Product Change Notice (PCN)

PCN Number: **PCN-0450975R-01**

Product(s) Affected: SJ1-3523N, SJ1-3524N, SJ1-3525N

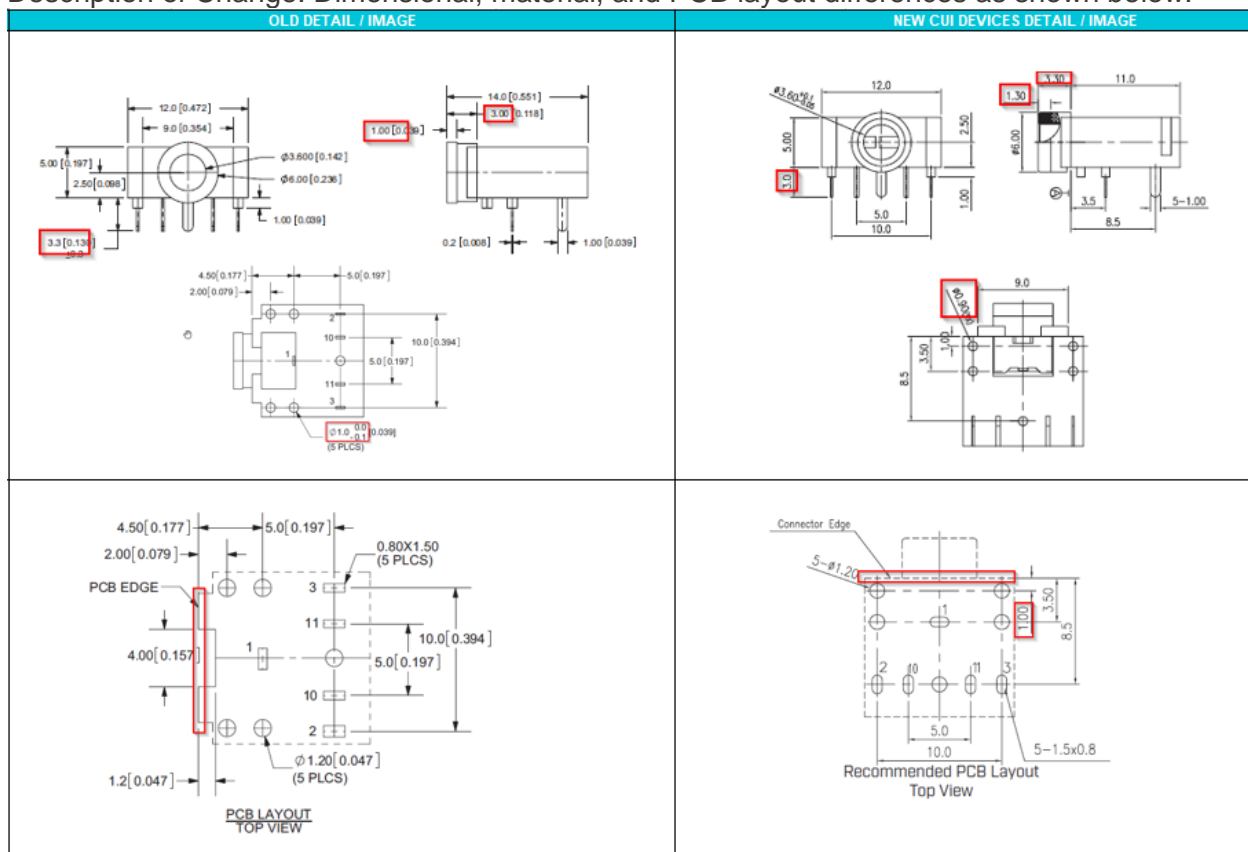
Reason(s) for Change: *Manufacturing process improvements*

Description of Change: Dimensional, material, and PCB layout differences as shown below:

MATERIAL	PLATING
terminal 1	copper alloy	silver
terminal 2	copper alloy	silver
terminal 3	copper alloy	silver
terminal 10	brass	silver
terminal 11	brass	silver
bushing	brass	nickel
plastic	PBT

DESCRIPTION	MATERIAL	PLATING/COLOR
terminal 1	copper alloy t=0.20	silver over nickel
terminal 2	stainless steel t=0.20	silver over nickel
terminal 3	stainless steel t=0.20	silver over nickel
terminal 10	brass t=0.40	silver over nickel
terminal 11	brass t=0.40	silver over nickel
bushing	brass	nickel
housing	PBT (UL94V-0)	black
